Reference	SSM71538
Models	XK / X150 XJ / X351 XF / X250
Title	Door Lock Cylinder Cover - Fitment at PDI / Replacement.
Category	Body
Last modified	05-Feb-2014 00:00:00
Symptom	112000 Latches/Locks & Security
Content	<p>Issue: Customer may report door lock cylinder cover missing.</p> <p>Cause: Cylinder cover may have been incorrectly fitted at PDI or after emergency vehicle entry.</p> <p>Action: The sequence of installing is shown on the attached doc. Please make sure that the door lock cylinder cover is pushed firmly in the sequence shown to install all 3 clips. The cover will now be securely attached to the vehicle.</p> <p><u>Ensure correct fitment by testing with a vigorous pull</u></p>

Reference	SSM71538
Models	XK / X150 XJ / X351 XF / X250
Title	Updated - Door lock cylinder cover, fitment at PDI / replacement
Category	Body
Last modified	30-Sep-2014 00:00:00
Symptom	112000 Latches/Locks & Security
Attachments	11Bezel SSM Images (1).pdf 1IMG_1198.MOV Bezel inspection.pdf
Content	<p>Issue: Customer may report door lock cylinder cover missing.</p> <p>Cause: Cylinder cover may be damaged or have been incorrectly fitted at PDI or after emergency vehicle entry.</p> <p>Action: 1) Insp

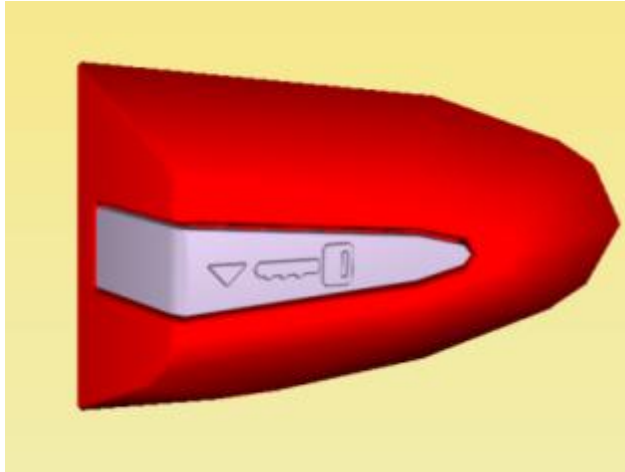
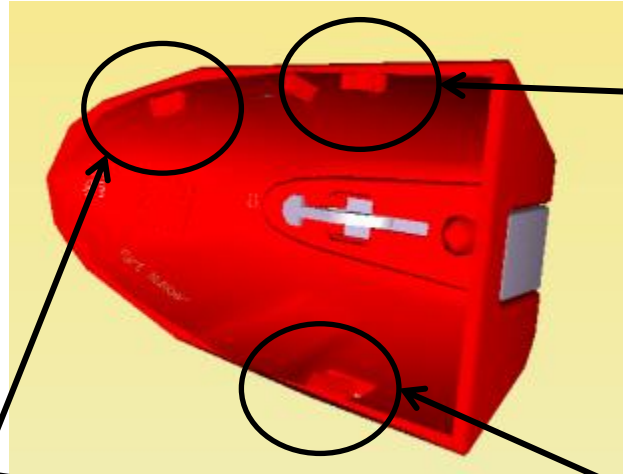
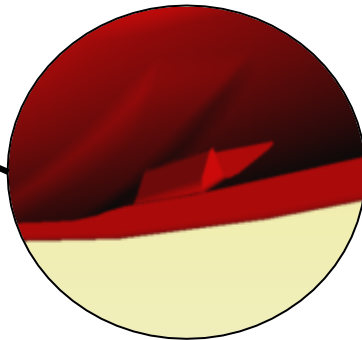
Reference	SSM71538
Models	XK / X150 XJ / X351 XF / X250
Title	Revised - door lock cylinder cover, fitment at PDI / replacement
Category	Body
Last modified	04-Aug-2014 00:00:00
Symptom	112000 Latches/Locks & Security
Attachments	Bezel SSM Images (1).pdf, IMG_0976 (4).MOV
Content	<p>Issue: Customer may report door lock cylinder cover missing.</p> <p>Cause: Cylinder cover may have been incorrectly fitted at PDI or after emergency vehicle entry.</p> <p>Action: The sequence of installing is shown on the attached doc. Please make sure that the door lock cylinder cover is pushed firmly into place so that an audible 'click' can be heard, following the sequence to install all 3 clips in the correct order 1-2-3. Ensure correct fitment by testing with a vigorous pull, the cover will now be securely attached to the vehicle as shown in the video attachment.</p> <p>NOTE: We are currently in the process of updating owner and PDI literature regarding this new revised procedure as current documentation may be incorrect.</p>

X351 Door Lock Bezel (LHD shown for illustrative purposes)

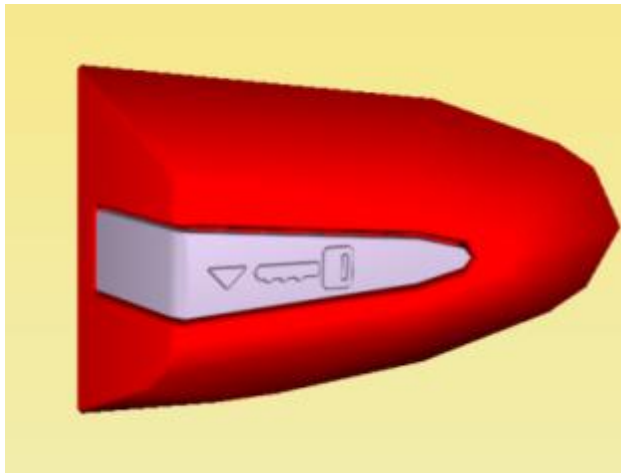
Areas of concern – 3 clipping tabs on inside of bezel (see highlighted below)

Tab should display the conditions shown – please record if any do not.

Inspect driver's door lock bezel prior to fitment.
